Evergreen Playfield

Mountlake Terrace Recreation and Parks Department

THIS DRAWING SET REFLECTS ON-SITE CHANGES FROM CONTRACTOR PROVIDED AS-BUILT DRAWINGS, AND DESIGN CHANGE DRAWINGS DEVELOPED DURING THE CONSTRUCTION PERIOD.

Project Record Drawings

Site Plan

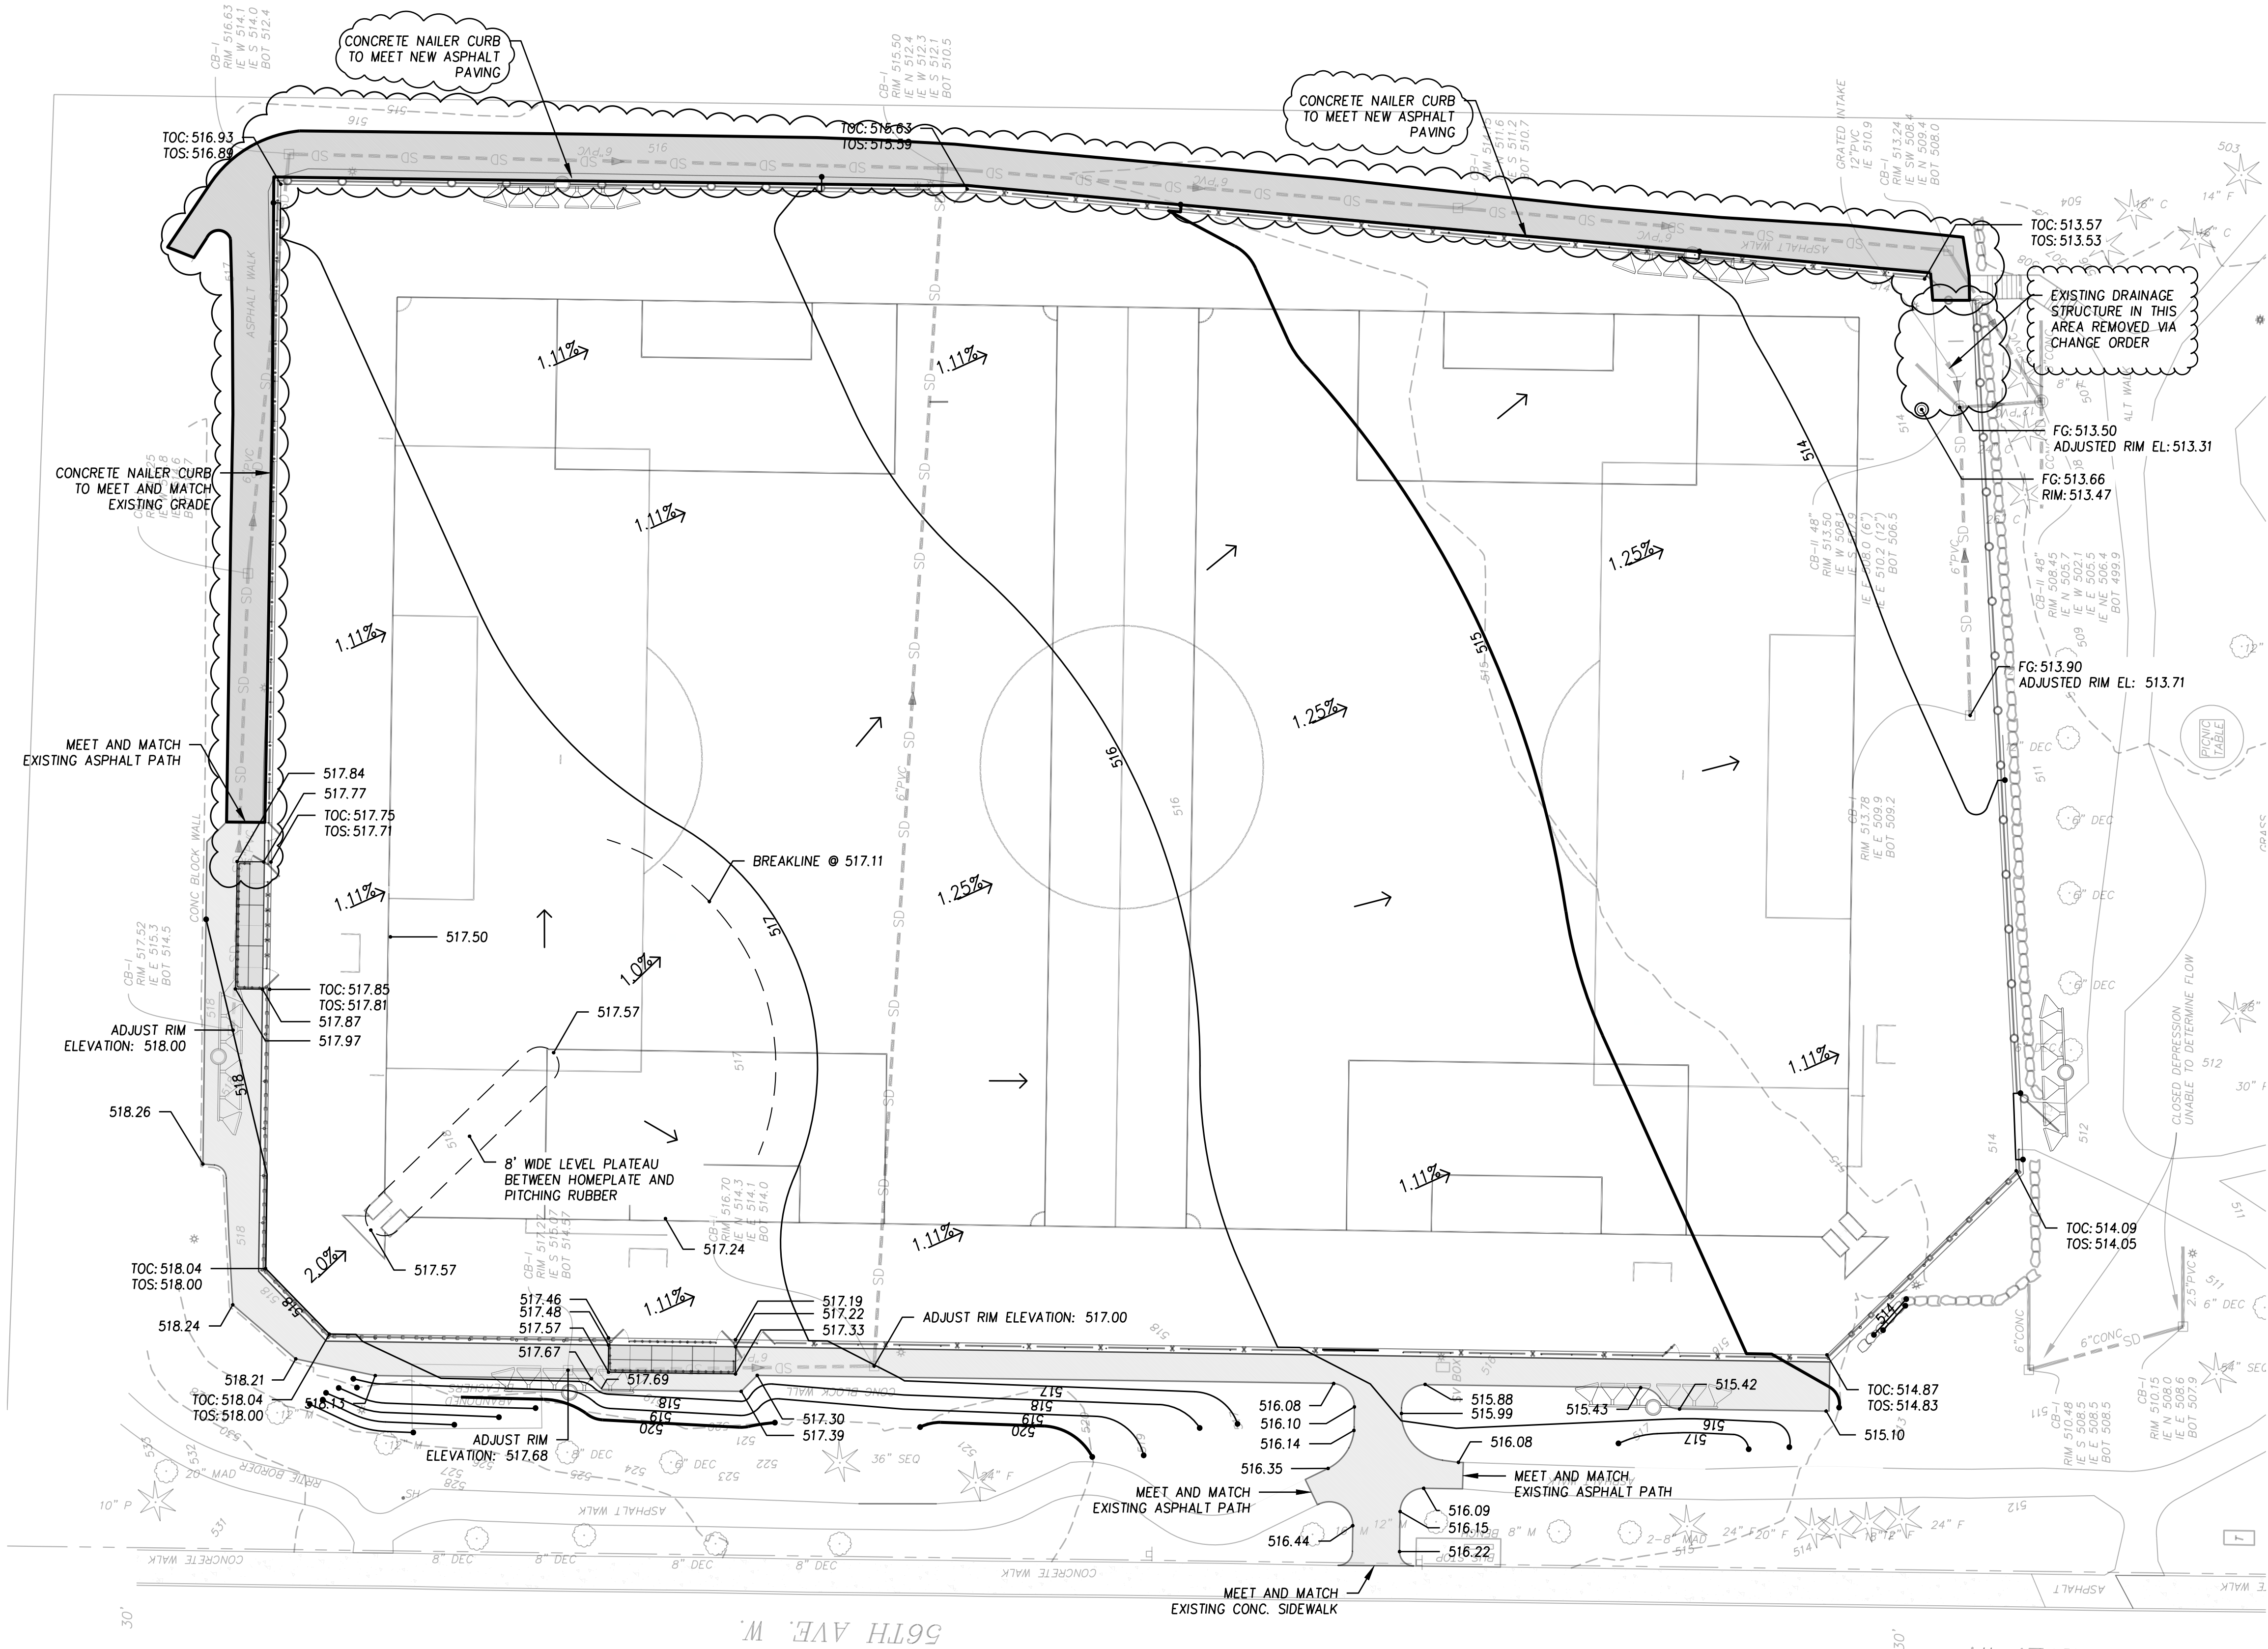
SYNTHETIC TURF INSTALLED
IN THIS AREA WHERE
EXISTING DRAINAGE
STRUCTURE WAS REMOVED
VIA CHANGE ORDER

2 Base Anchor and Footing
C6.1 SCALE: 1 1/2"=1' NOT USED - BASE ANCHORS DELETED - REPLACE WITH INLAID TURF BASES IN THE FIELD.

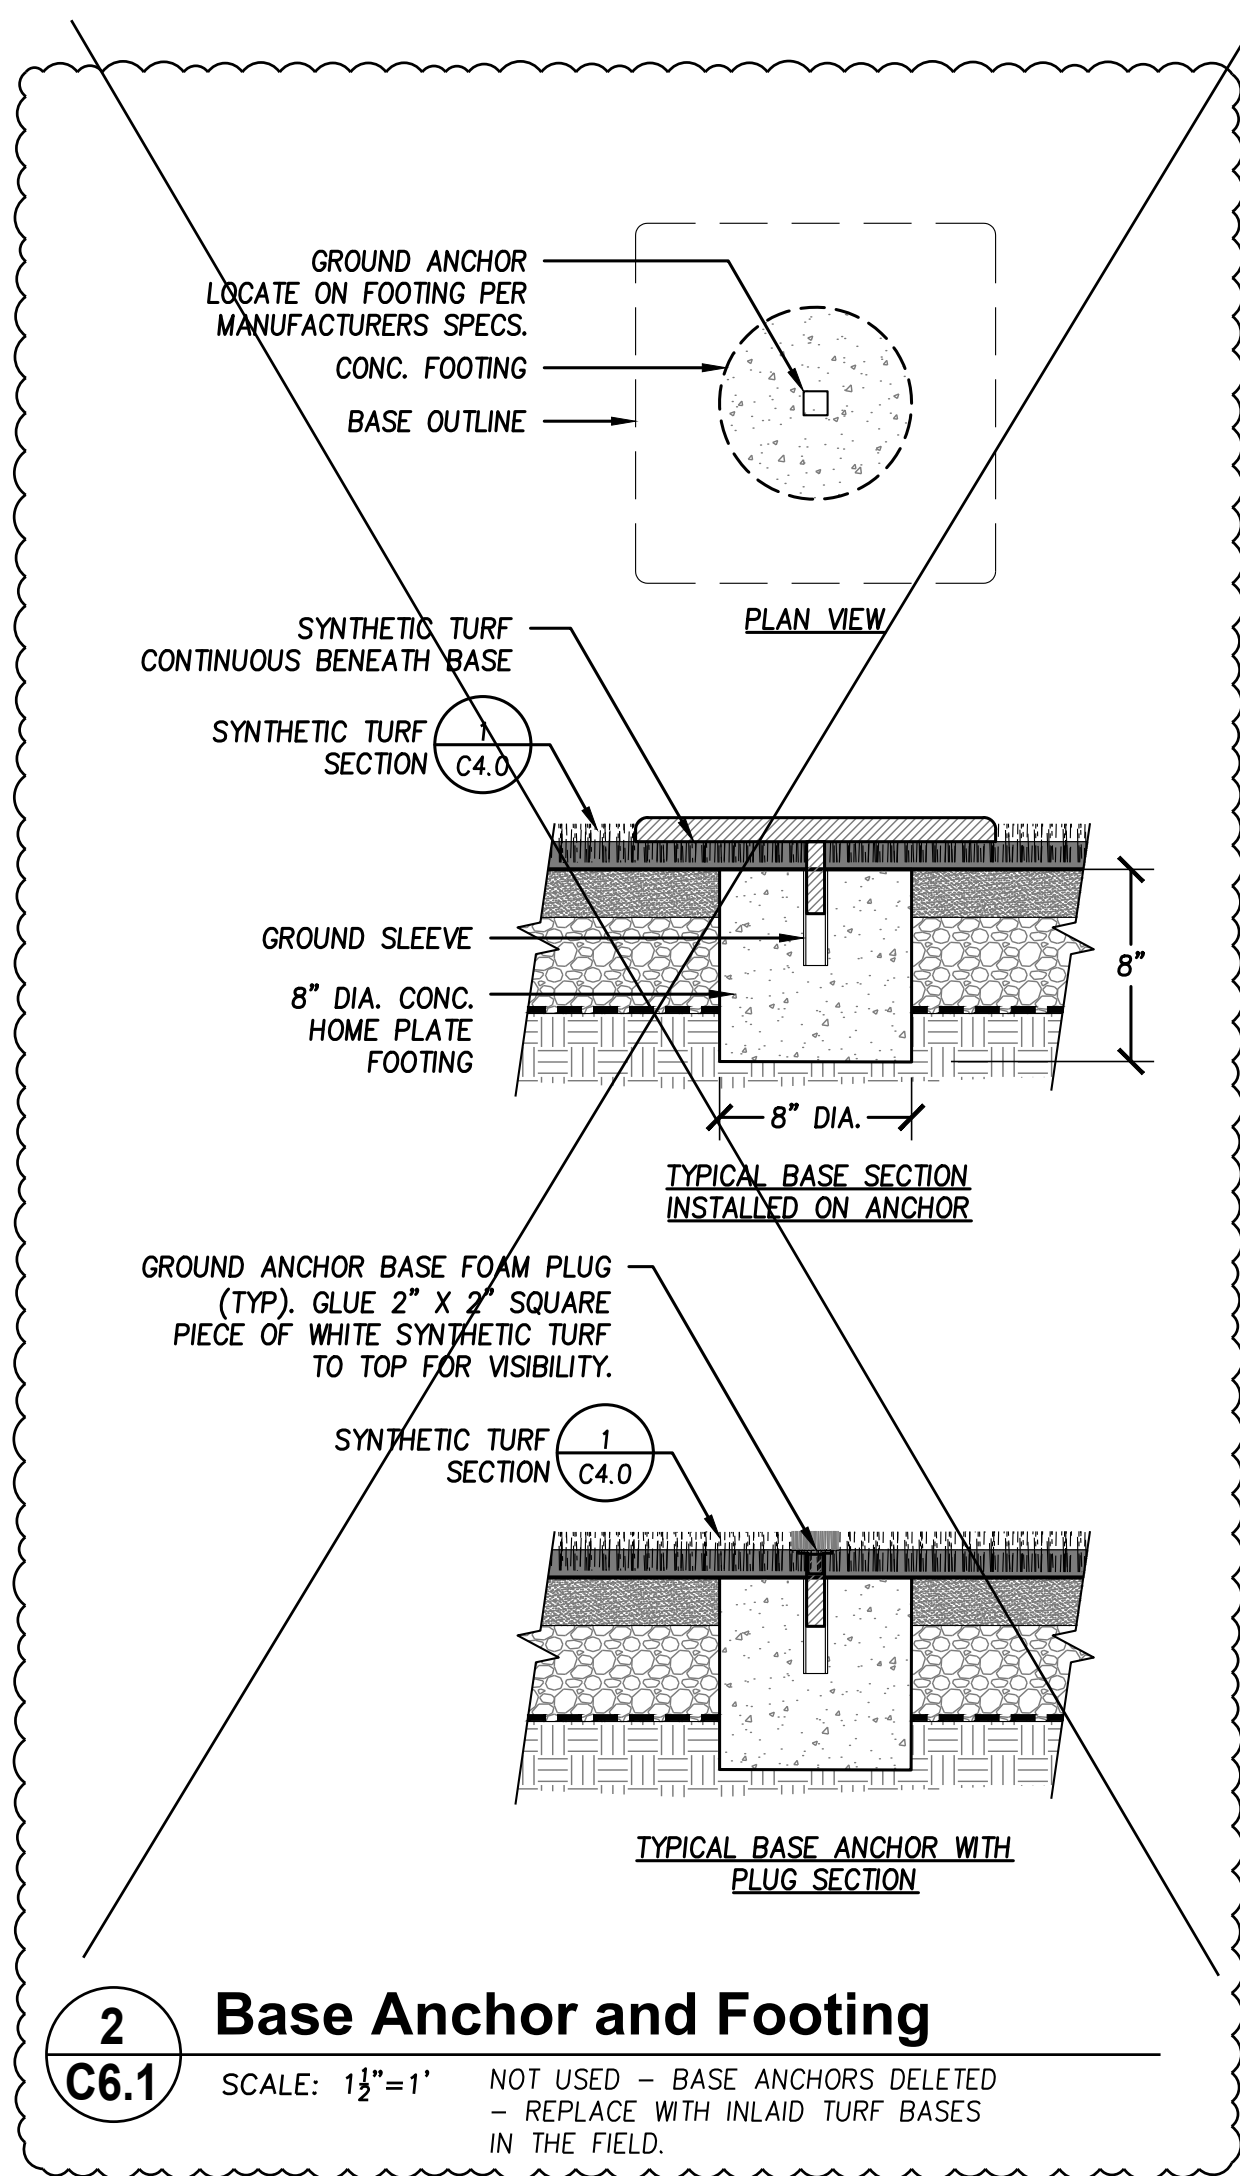
BASES AND BASE ANCHORS IN THE FIELD (FIRST, SECOND, AND THIRD) WERE DELETED FROM PROJECT, AND REPLACED WITH WHITE SYNTHETIC TURF BASES INLAID DURING CONSTRUCTION.
